Voltage Divider Board

WA105 TB Meeting

Review committee report

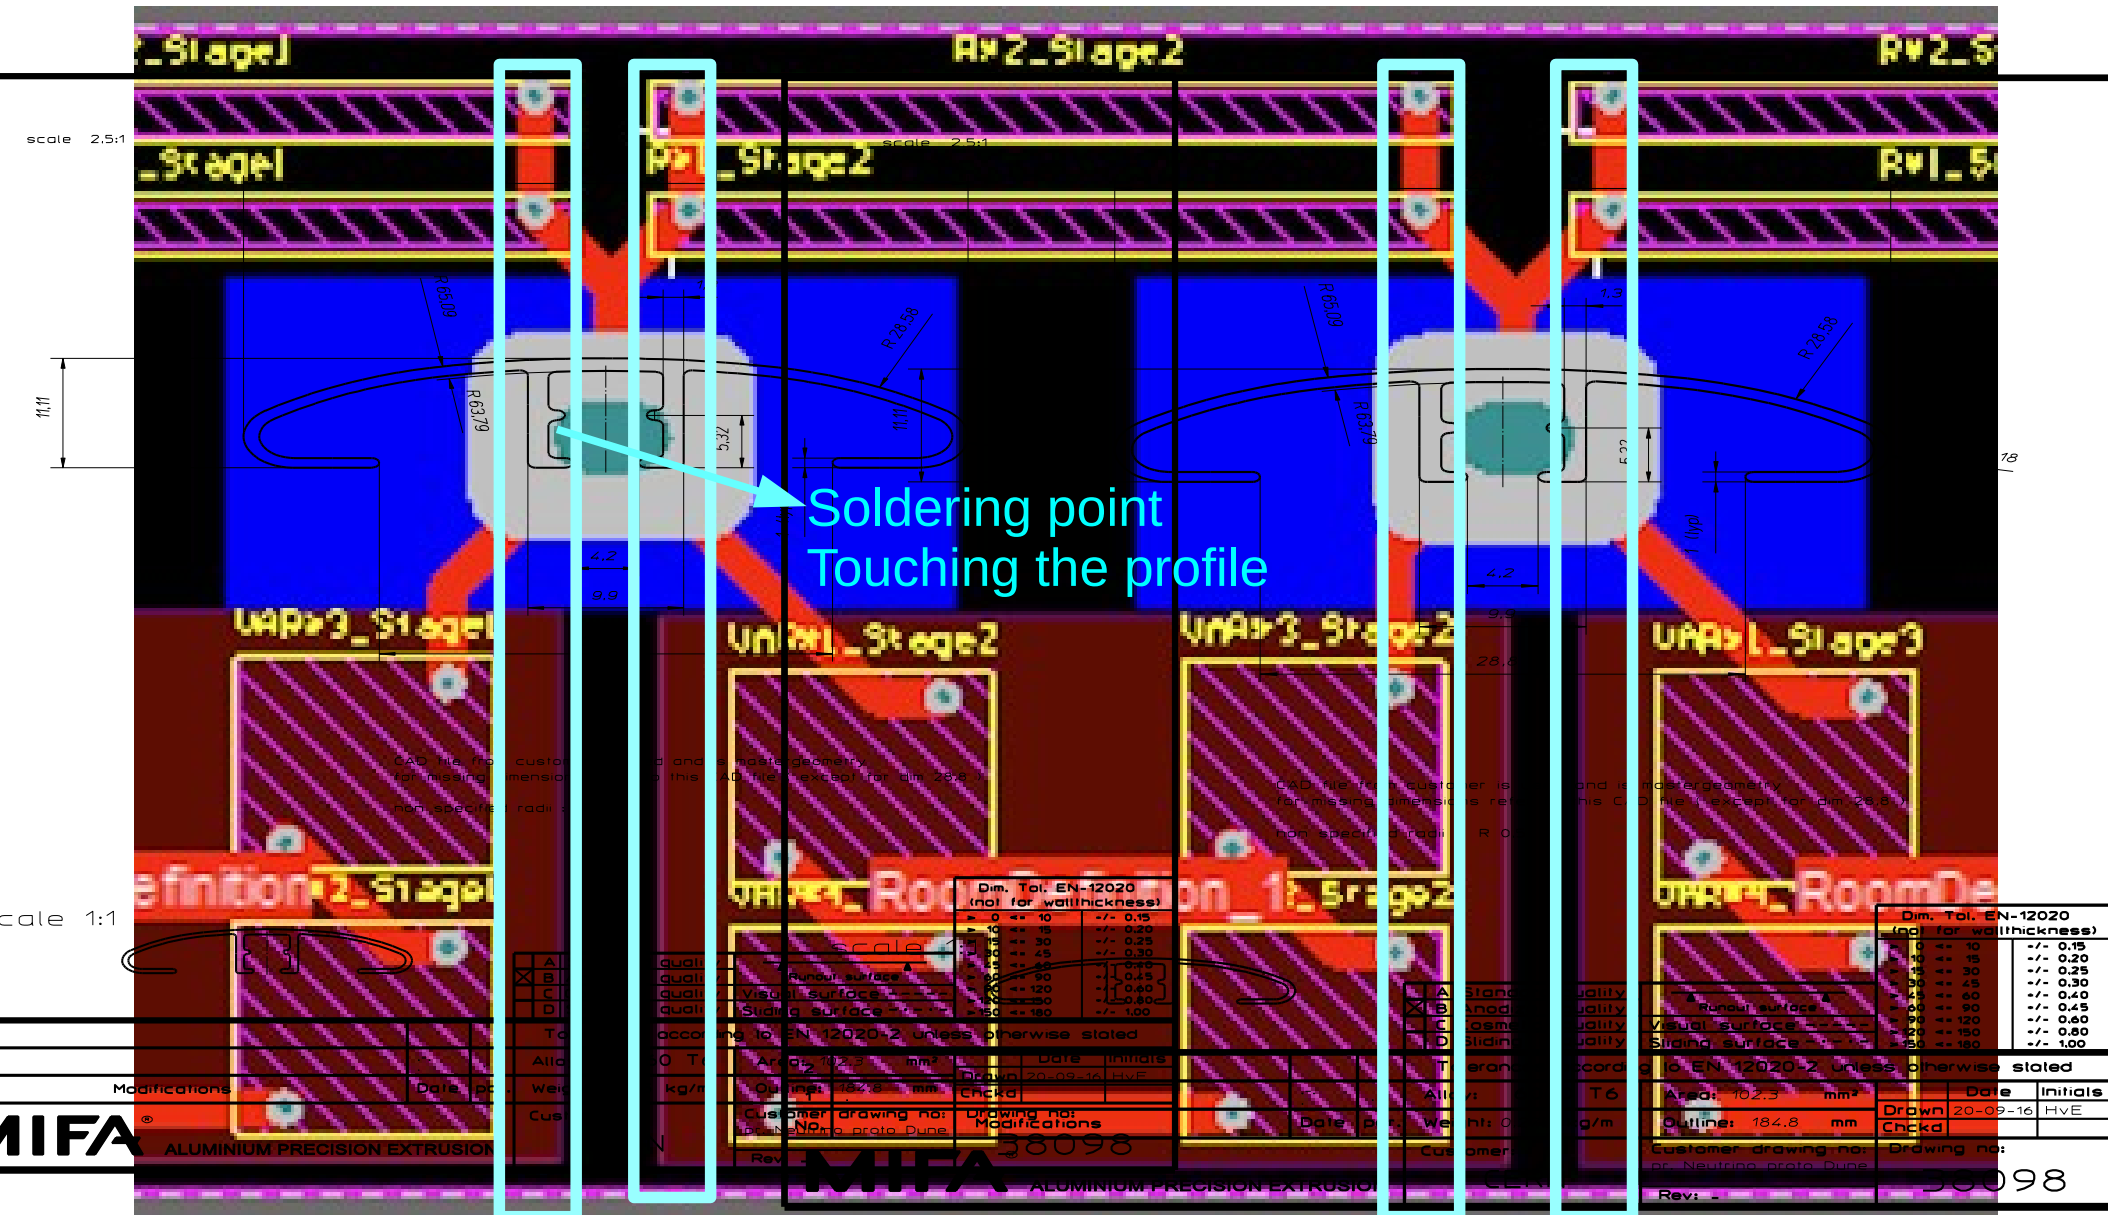
- “The UTA group should verify that the through hole (solder bump) locations on the resistive divider boards are not shorting out or come close to the Al profile when mounted”.

1st issue : Shorting between two Profiles

2nd issue: Soldering bump touching Alu profile

Modifications of a single stage design (Auto CAD drawing)

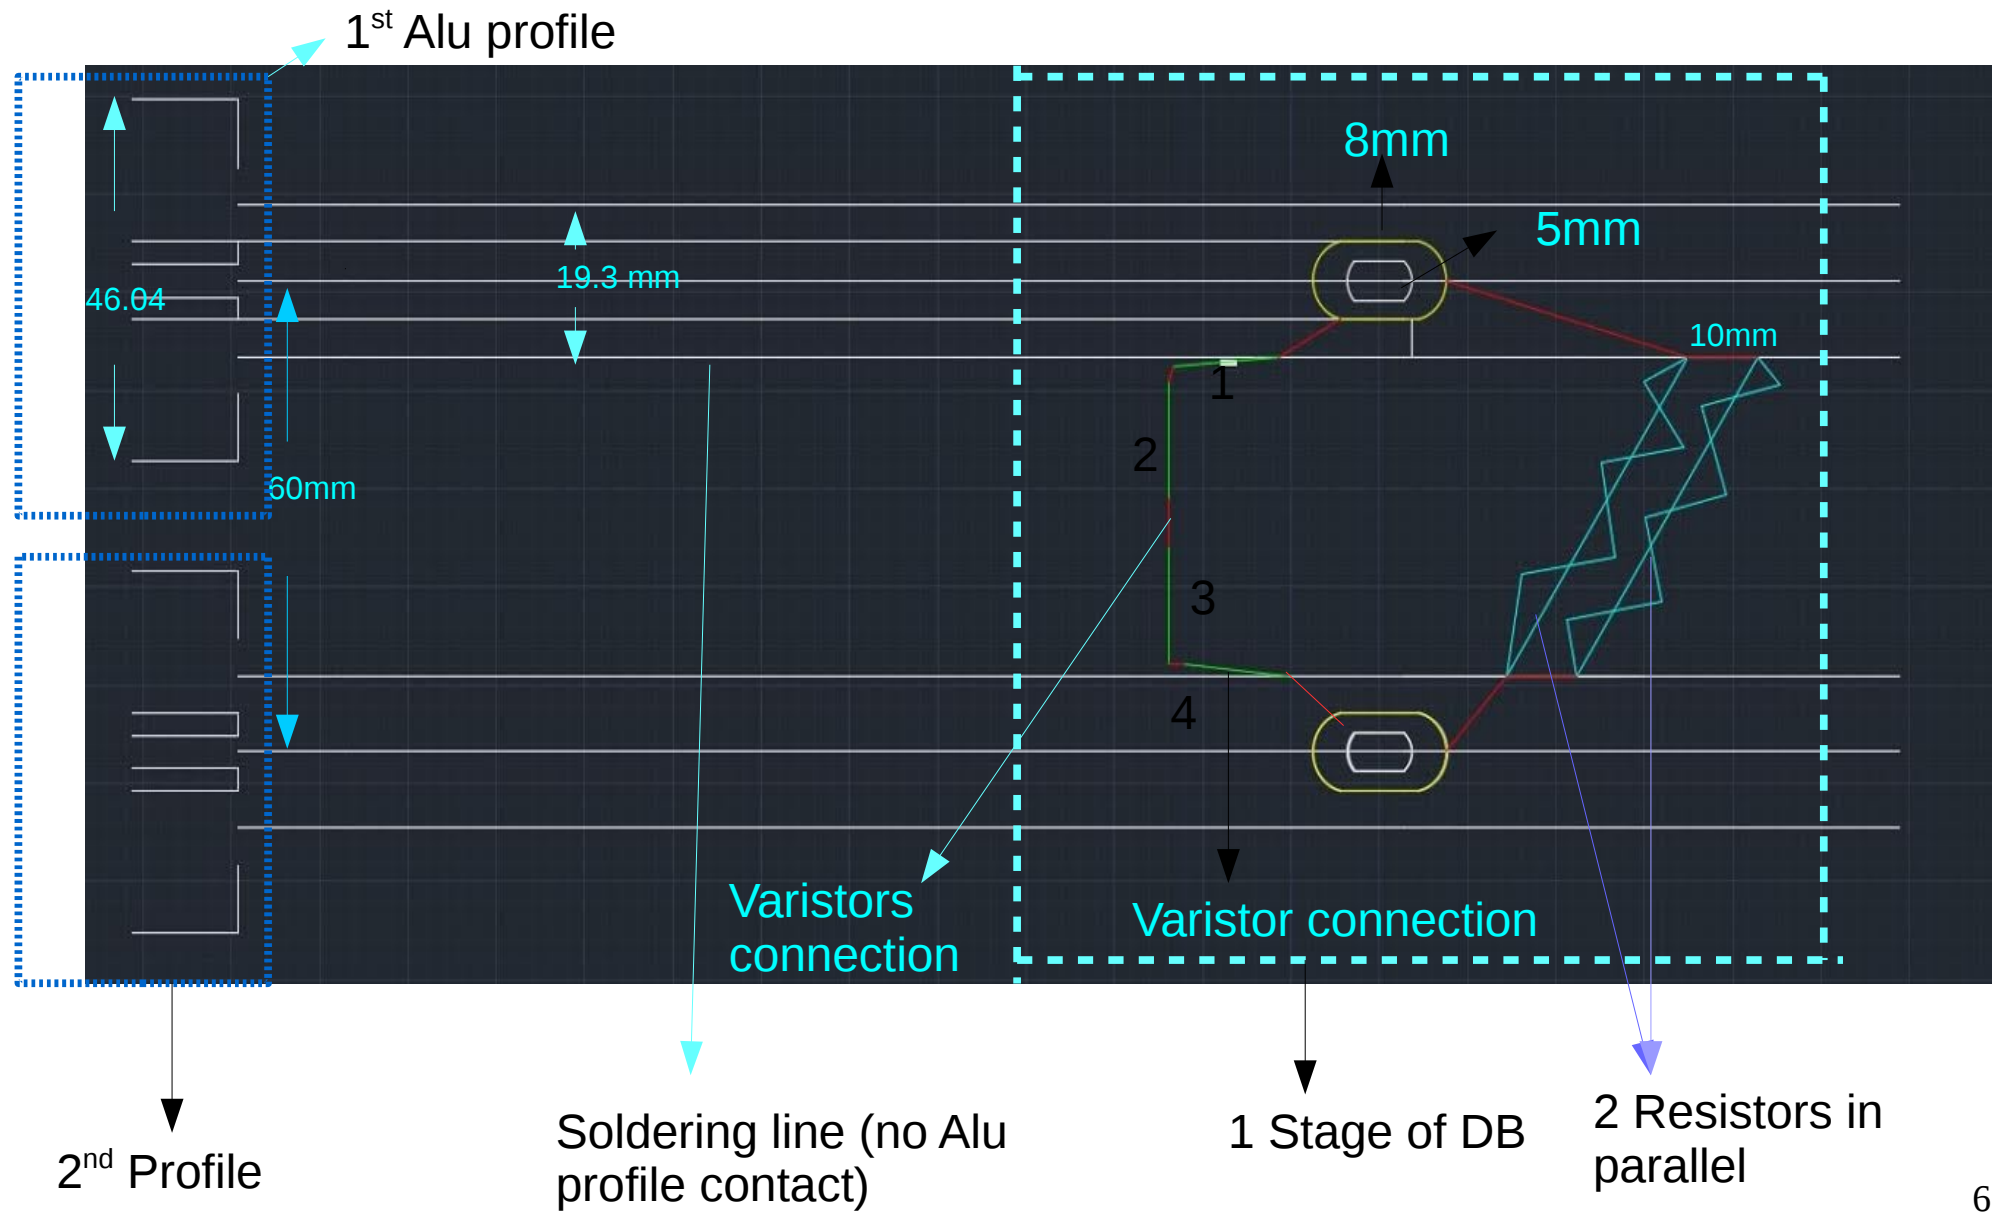
Modifications: PCB board design

- *Remove the shorting point between varistors*
- *Soldering bump both for the resistors and varistors should not touch the Alu profile.*
